Access Compliance Report

Public Rights-of-Way

(Curb Ramps)

Intersection ID: 14620	Main Street: EUCLID_AV	Cross Street: MCDONALD_AV	Location: E
ADA ID: 8FBDF5C58E23	Ramp Type: Directional1	Initial Pass/Fail: Pass	Overall Compliance: No
Severity Score: 2.5			
Codes/Mitigation Info/Possible Solution		Field Measurements/Component Compliance

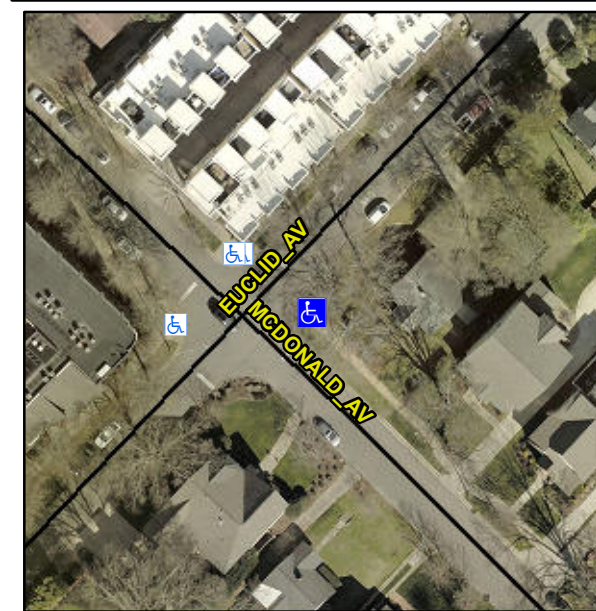
Remove & Replace Detectable Warning System.

R305.1.4
